**CITY OF LA VISTA**  
**MAYOR AND CITY COUNCIL REPORT**  
**JULY 15, 2014 AGENDA**

<b>Subject:</b>	<b>Type:</b>	<b>Submitted By:</b>
CONDITIONAL USE PERMIT AMENDMENT ~ MY PLACE HOTEL LOT 3, SOUTHPORT EAST REPLAT THREE	◆RESOLUTION ORDINANCE RECEIVE/FILE	ANN BIRCH COMMUNITY DEVELOPMENT DIRECTOR

RE: Conditional Use Permit Amendment & Administrative Plat  
My Place Hotel  
Lot 3, Southport East Replat Three  
Initial City Engineer Review

RE: Design Review – My Place Hotel  
BCDM Project No. 3700-07

DUMPSTER  
ENCLOSURE  
A202  
PROJECT #  
1418-01

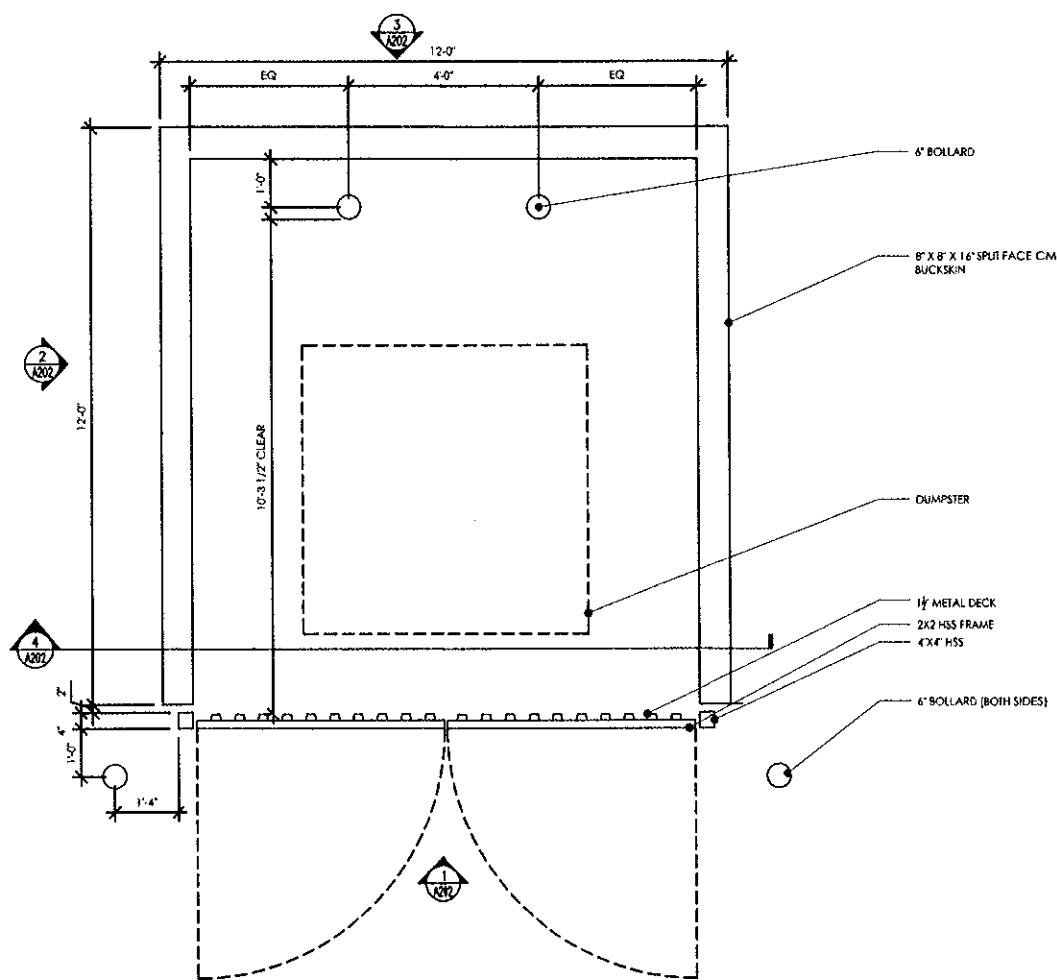
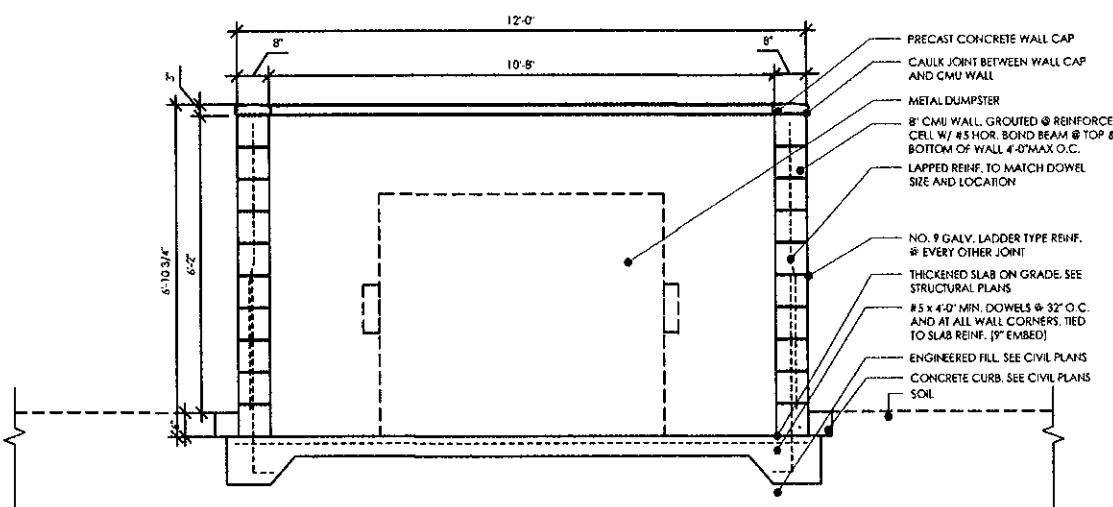
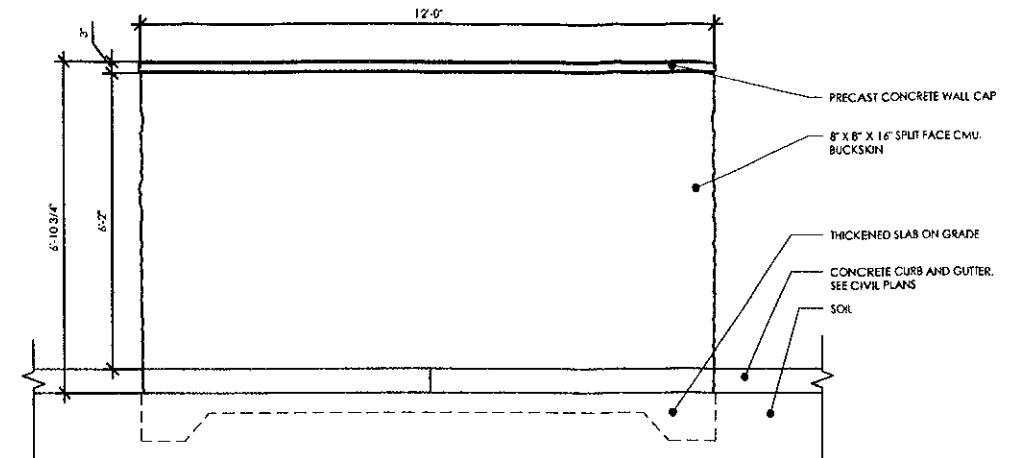
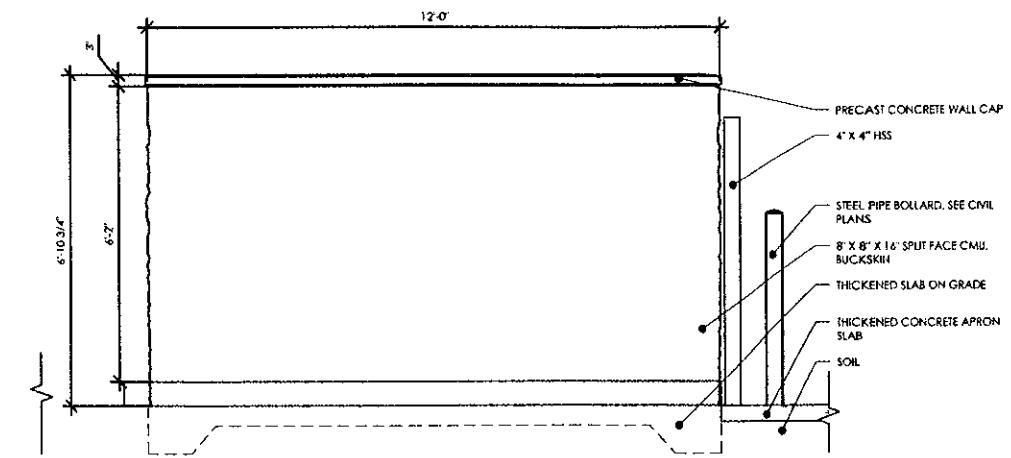
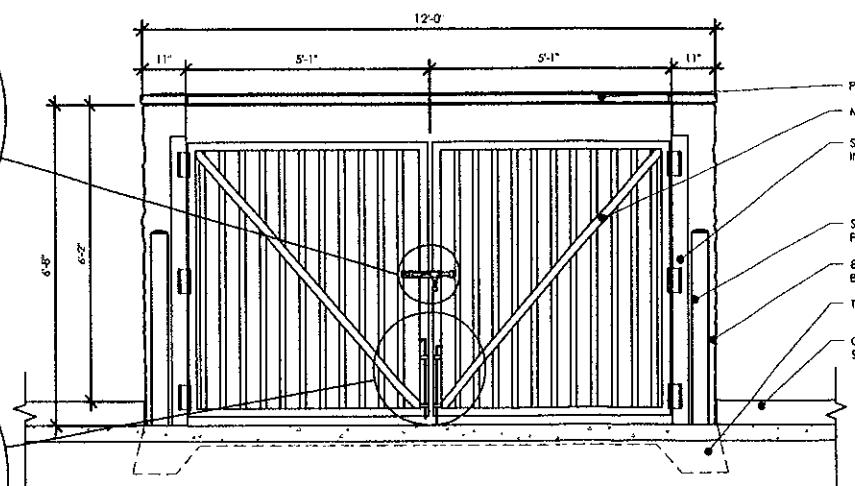
- c. Trash Enclosure
  - i. The site plan (Exhibit "C100") and elevation (Exhibit "A202") indicates screening (trash enclosure) around the refuse dumpsters. The walls of the trash enclosure are to be constructed of masonry units to match the material on the main structure. Two gates with steel frames will be utilized on the enclosure.

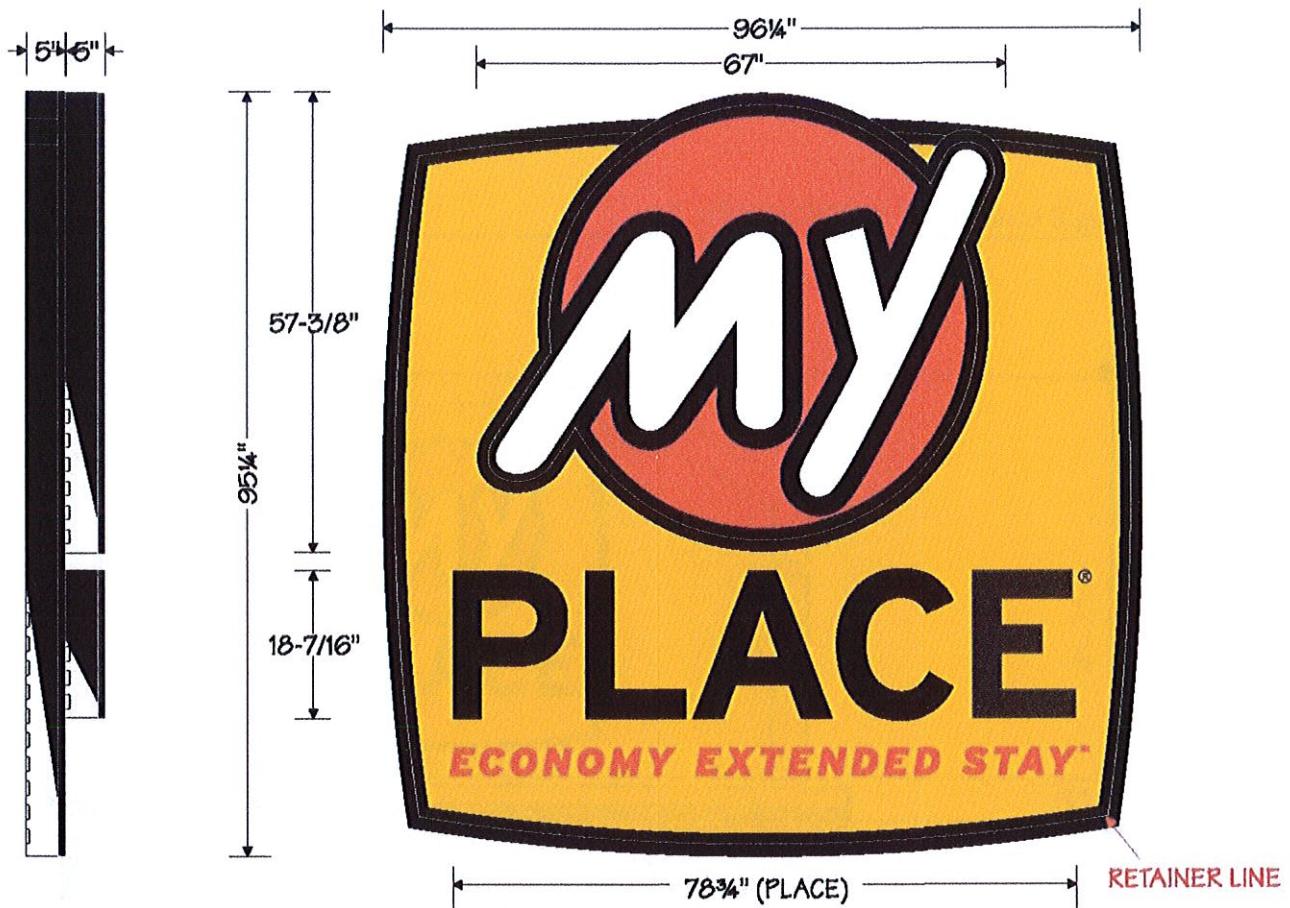
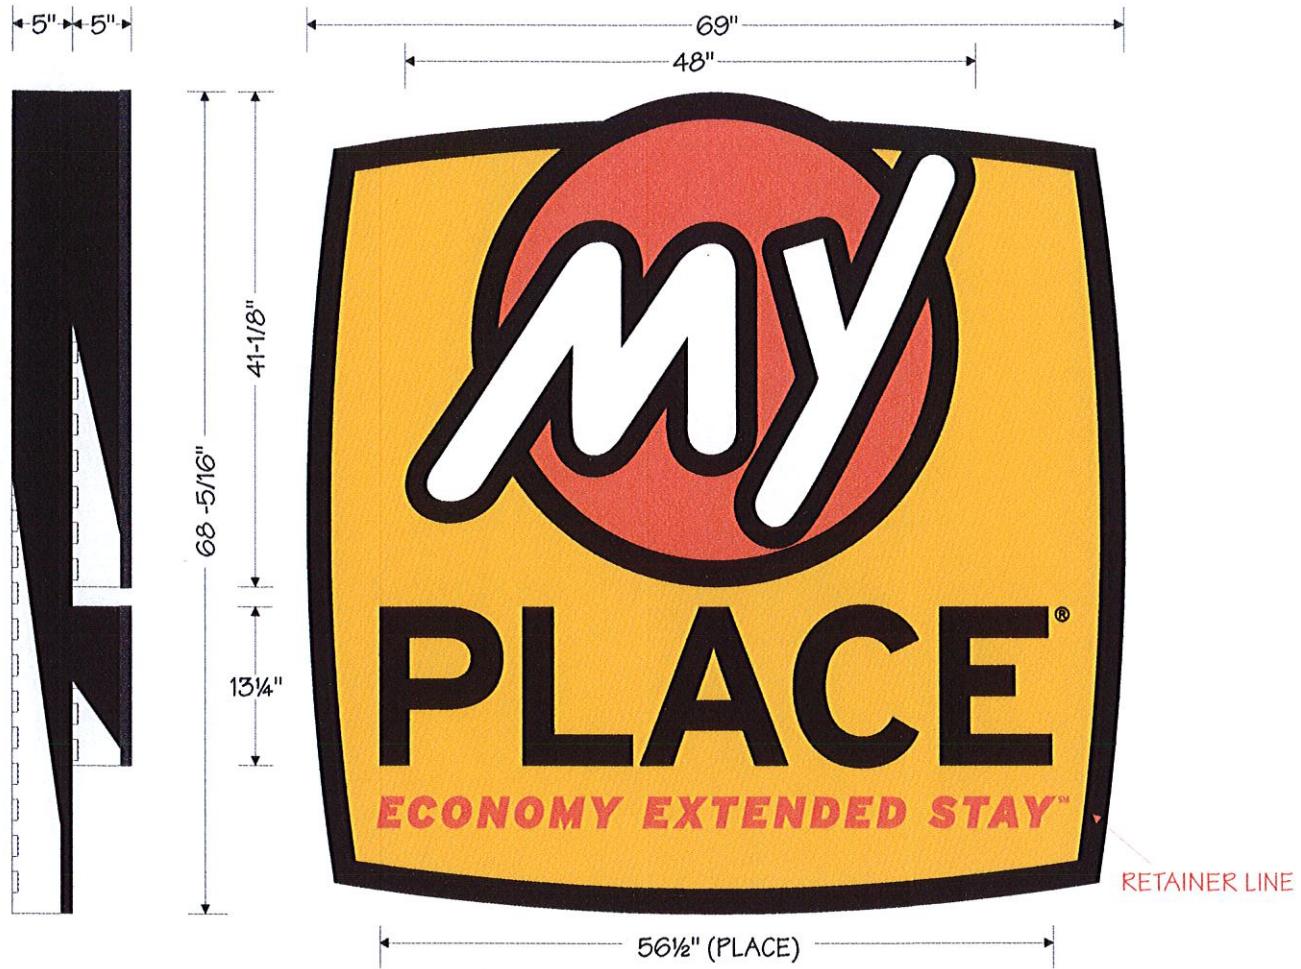
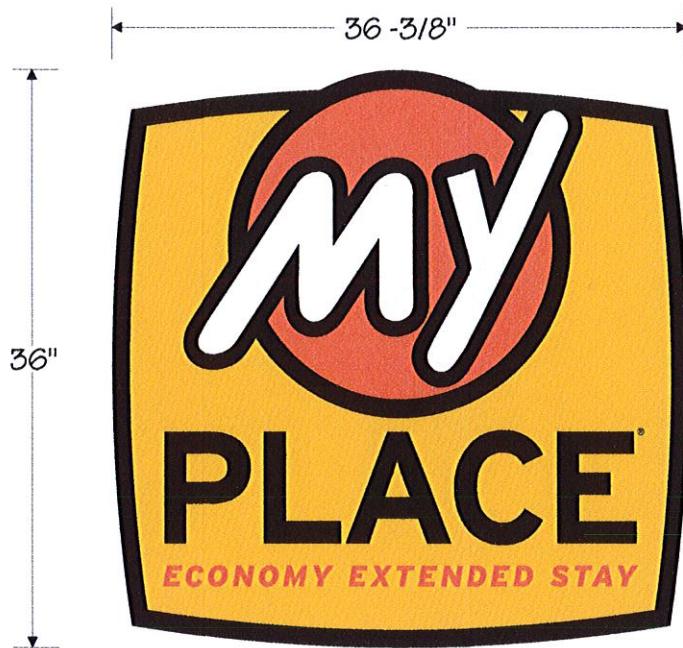
- All building signs shall be individual can letters. Color of letters is up to the Building owner.
- Individual can letters on building not shown. Singular sign is not compliant with this requirement. Signage reviewed by City.  
**Not in Compliance.**  
**Signage has been described in more detail including trademarked signage as shown.**  
**Signage is required to be modified to comply with guidelines. (See Fantasy Car Wash ie.) Signage is reviewed by City for compliance.**  
**Signage is required to be modified to comply with guidelines. (See Fantasy Car Wash ie.) Signage is reviewed by City for compliance.**  
**Signage has been modified to more closely comply with guidelines. Signage is reviewed by City for compliance.**

**BUILDERS HARDWARE SPECIFICATIONS**

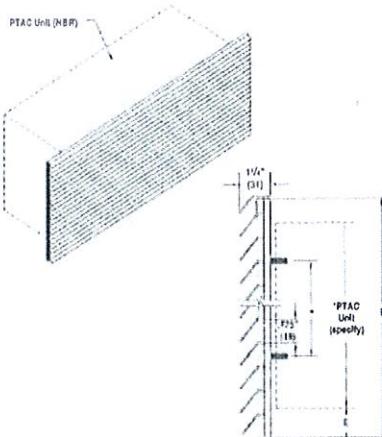
- Motel/hotel PTAC thru-wall units are to be screened.
    - Provide information and details on screening to be incorporated into thru-wall units shown.

- Not in Compliance.**
  - Information has been provided for PTAC grilles.**
  - **Submittal is Compliant**
  - B. *Ground level mechanical equipment is not shown. Provide information showing locations of any and all pedestals, building utilities etc.*
